Shearwater Teric Firmware Release Notes

เวอร์ชัน 21 2021-11-01

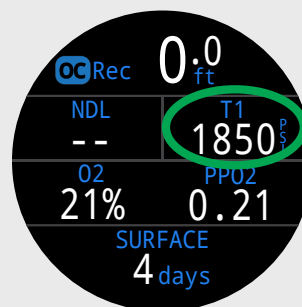
NEW Lower frequency option added for beeper, which may be easier for some users to hear.
